Re: Clinch River Breeder Reactor Plant - Docket No. 50-537

Enclosed are errata sheets for Applicants' prepared testimony (A Exh's 87, 89, and 95) in the above captioned proceedings. At the evidentiary hearings Applicants will offer versions of Exhibits 87, 89, and 95 which will have the attached errata clearly marked and inserted.

APPLICANTS' DBA TESTIMONY (EXHIBIT 87) ERRATA

Figure 35. SHRS AC Power Supplies

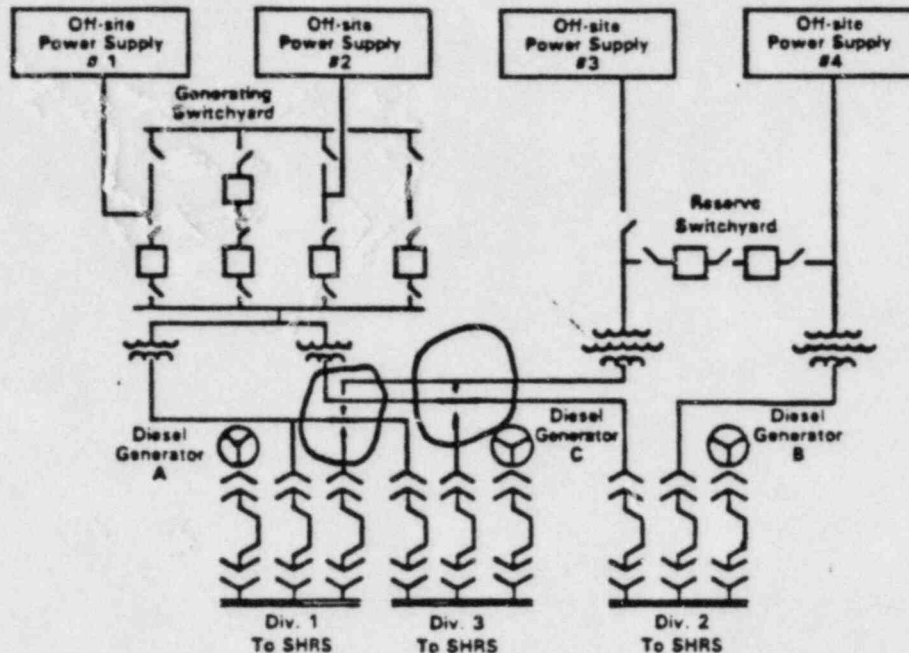
Page 68	Lines 9, 10	Replace comma after "power" with period; capitalize "because"
Page 81	Line 5	Insert "unacceptable" before "degradation"
Page 95	Figure 35	Modify per attached mark-up
Page 99	Figure 38	Modify per attached mark-up
Page 116	Line 8	Change "mills" to "mils"
Page 126	Lines 17-19	Revise to read "...wall penetration would occur when the crack length is very small..." (Delete Line 18 entirely.)
Page 140	Line 7	Insert "heat" after "generate"
Page 165	Line 22	Change "Qalification" to "Qualification"
Page 206	Line 1	Add "Table 6" above "SSST Guidelines and Doses"
Page 206	-----	In the "Low Population Zone" column, change the "Red Bone Marrow" entry from 1.5 to 0.7 and change the "Mortality Risk Equivalent Whole Body Dose" entry from 0.7 to 1.5
Page 210	Line 7	Change "zircoloy" to "Zircaloy"
